SERVICEORDRE – 2018-02

Date: 10 October 2018	Service Bulletin #: 081018	# of pages: 6
Subject: RSL with Reserve Boost Mard (Main Assist Reserve Deployment)		
Status: Mandatory

- RSL with Reserve Boost Mard (Main Assist Reserve Deployment)

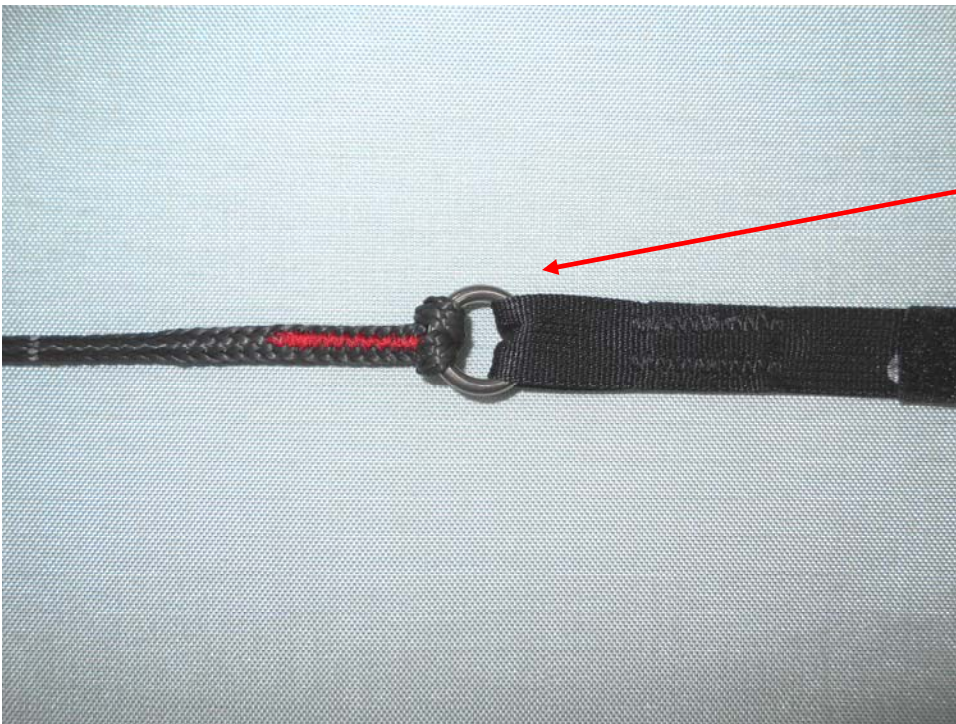
A jumper with the Wings Reserve Boost System had a Reserve Deployment Hesitation involving the Lanyard and Reserve Ripcord Cable. After evaluation of the incident we have decided to modify the Reserve Boost Assembly. This modification is **Mandatory** on or before your next reserve repack. Please see the pictures with text and follow these instructions to modify your Reserve Boost to the new configuration.

This Service Bulletin involves Reserve Ripcord Cable/Pin and Reserve Boost Lanyard.

Original RSL for “Reserve Boost” on ***Wings*** Reserve Containers.

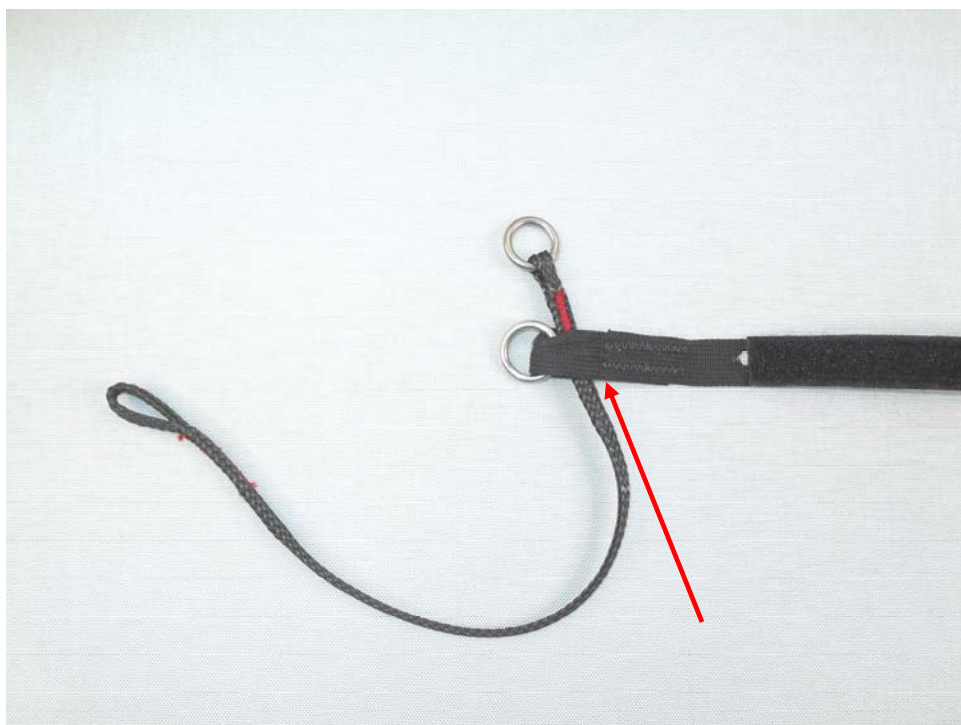
Notice “Lark’s Head” knot on the ring.

Remove HMA line from the mini ring.

Pass the mini ring through the opening between the ring and the Zig-zag stitching on the T-IV RSL.

Pass the mini ring of the HMA line through the loop on the end of the "Reserve Boost" lanyard.

Tighten the knot formed.
